PARTS PE EVALUATION REPORT

SUPPLIER	TDM - SMA
PART NUMBER	KD04629-Y612

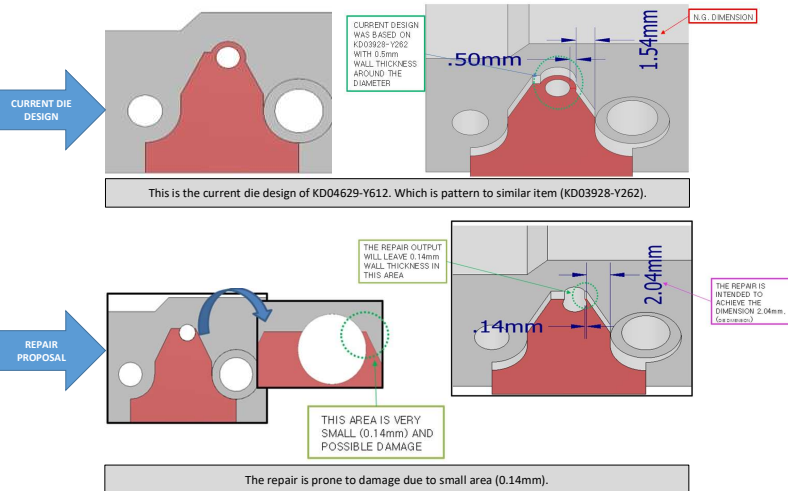
Hinsei Request -> Different Shape

The design of Y612 is similar with Y262

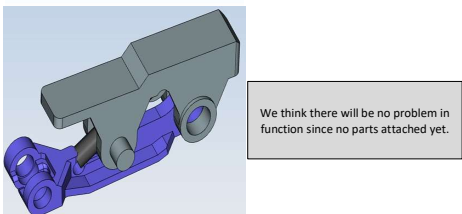
Actual data:

Root
Go : +0.09
Stop : +0.10

Tip
Go : -0.62
Stop : -0.55

Hinsei Request -> 3 (+0.10 /-0.70)
